KEYSTONE XL PIPELINE PROJECT

0311-SD-P4-370.2-370.8-S

KEYSTONE XL PIPELINE PROJECT PIPELINE ROUTE VARIATION FORM			
1	<b>VARIATION TYPE:</b> Refinement: <input type="text"/> Reroute: <input checked="" type="checkbox"/> Footprint: <input checked="" type="checkbox"/> Design: <input type="text"/> Centerline: <input checked="" type="checkbox"/> Pump Station: <input type="text"/> Valve Site: <input type="text"/> CAR: <input checked="" type="checkbox"/>		
2	<b>LOCATION:</b> Sketch: <input type="text" value="Attached"/> Pictures: <input type="text" value="N/A"/> State: <input type="text" value="SD"/> County: <input type="text" value="Perkins"/> Quad Map: <input type="text" value="N/A"/> Township: <input type="text" value="13N"/> Range: <input type="text" value="10E"/> Aerial Map: <input type="text" value="See attached map sheet"/> Section: <input type="text" value="13,18"/> Centerline: <input type="text" value="3/14/2012"/> MP: <input type="text" value="370.17"/> to <input type="text" value="370.76"/>

*Proposed Route Variation 0311-01*

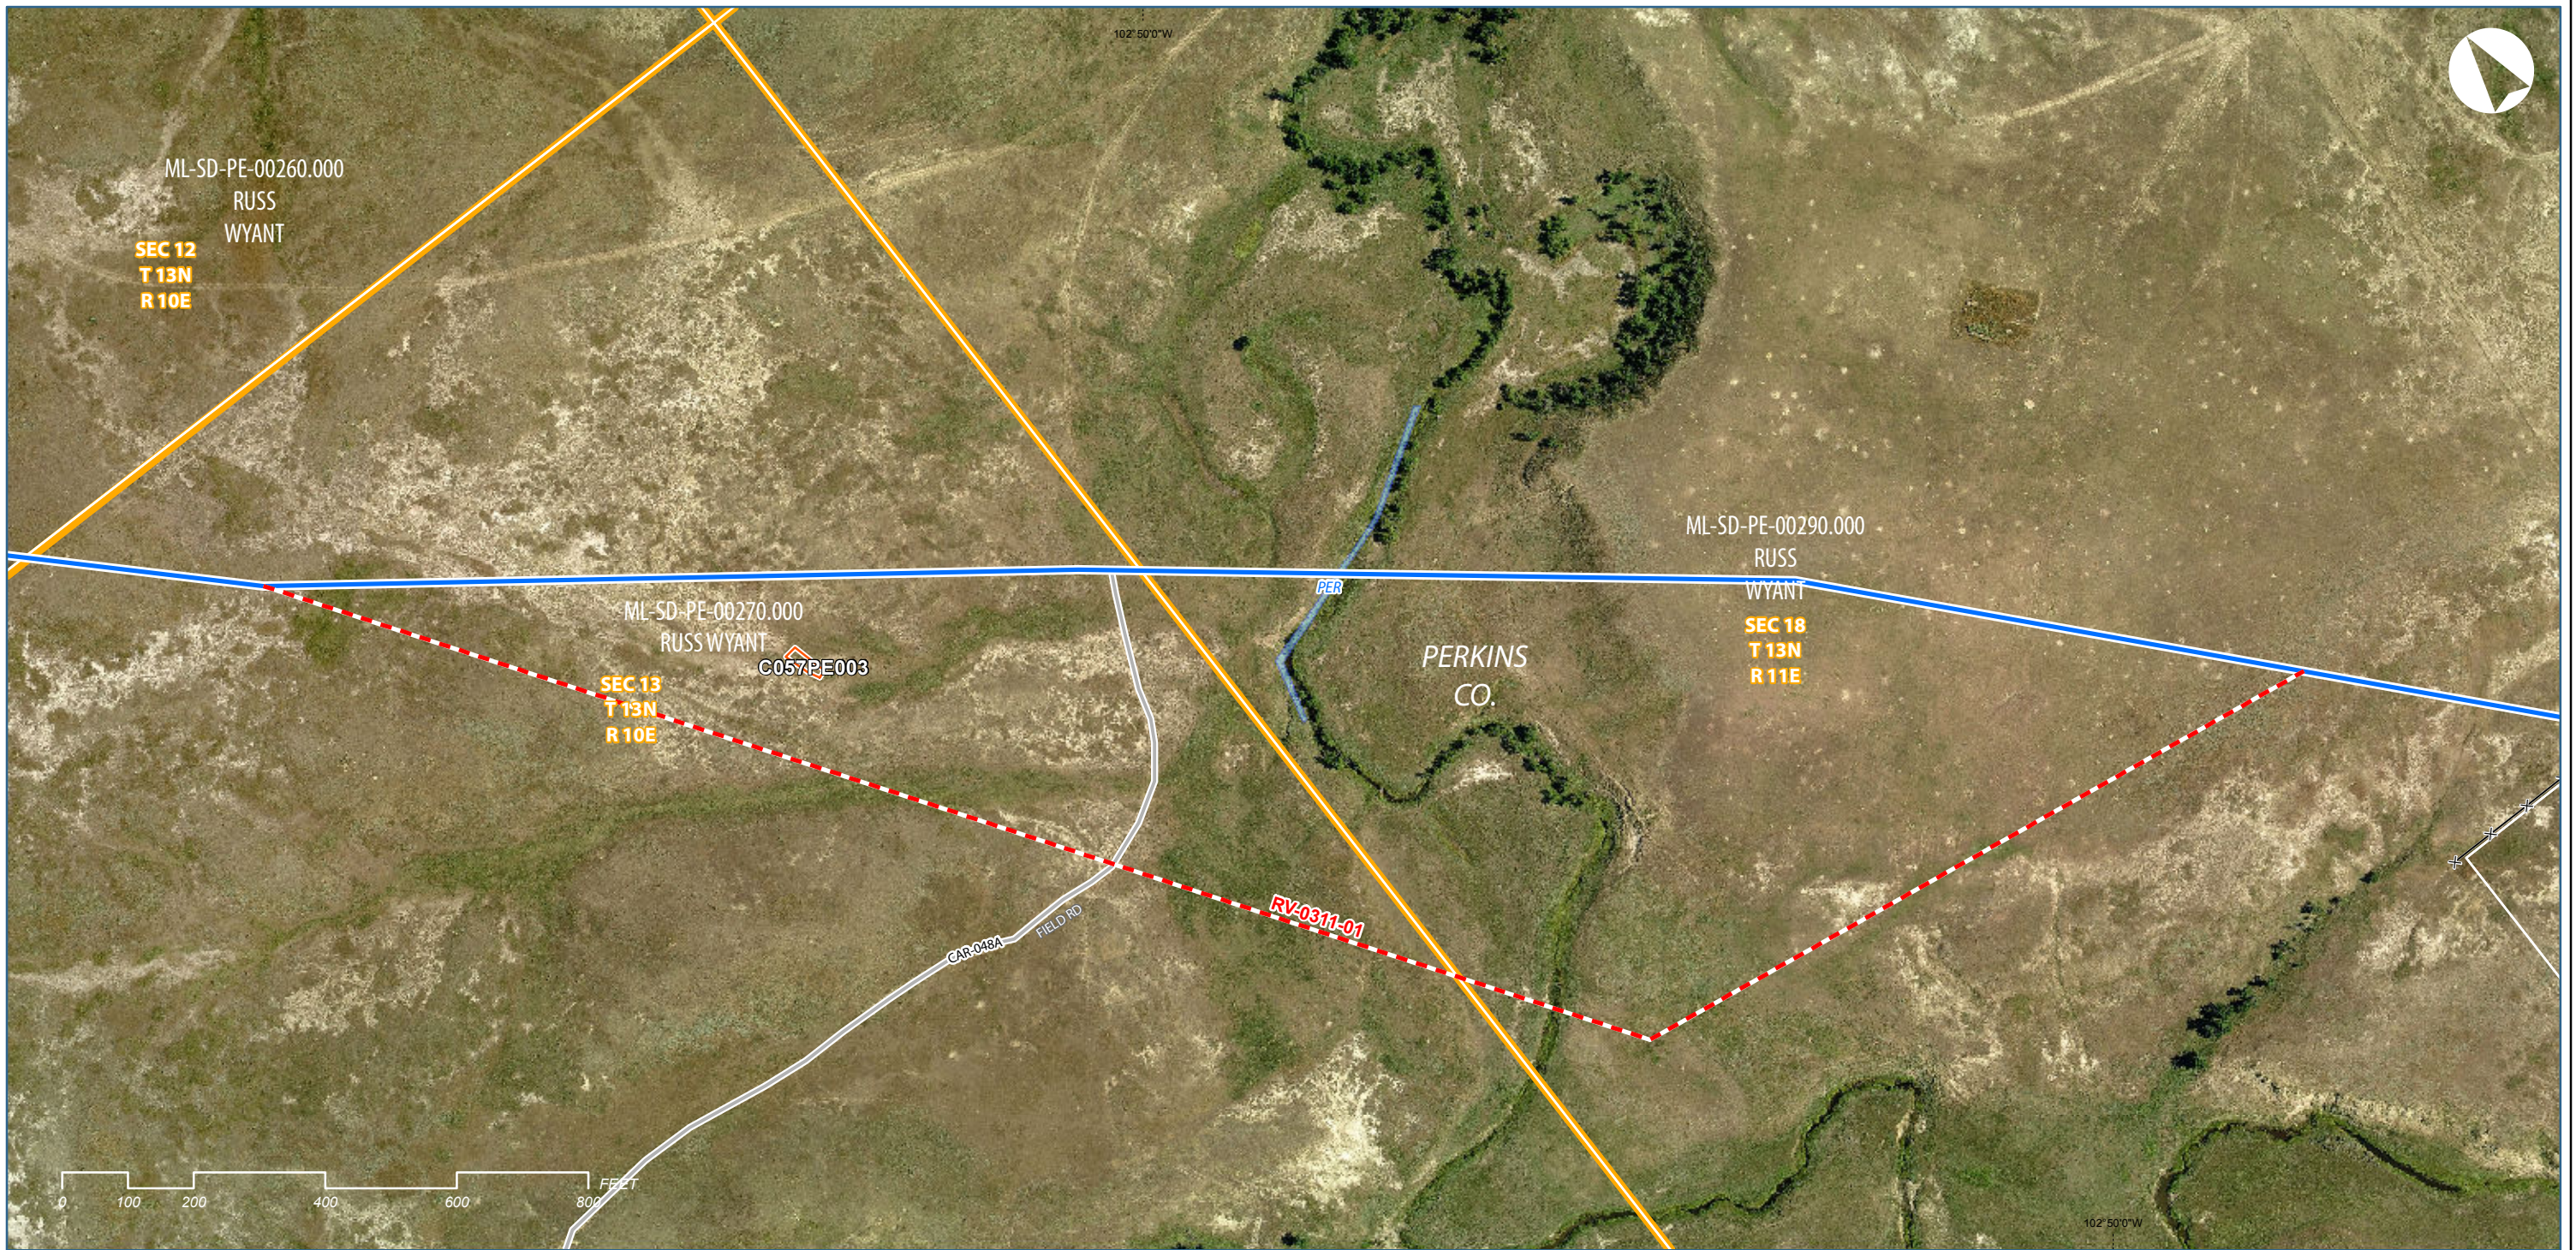
3	<b>REASON FOR ROUTE VARIATION</b> (Please include reason for route variation): The primary reason for this proposed route variation is to shift the centerline and workspaces away from a potential unmarked grave site and to a better creek crossing location (gentler slopes).  This reroute is requested by Engineering and is based on field civil survey data.		
	<b>DETAIL ROUTE VARIATION</b> (Please describe route variation in detail): The proposed route variation starts near MP 370.2 and deviates ~19° southeast of the current CL. It continues in this direction for ~2,218 ft. Then the reroute turns east and extends for ~1,141 ft. to rejoin the current CL near MP 370.8.		
	<b>ADDITIONAL IMPACTS</b> (Please include any additional impacts which may affect cost; crossings, induction bends, etc.): 2 tracts are impacted by the reroute: ML-SD-PE-00270.000 and ML-SD-PE-00290.000 (both Russ Wyant)  CAR-048A is impacted by this proposed reroute (will be shortened).  Cost savings are ~500,000 for a potential contractor move around.
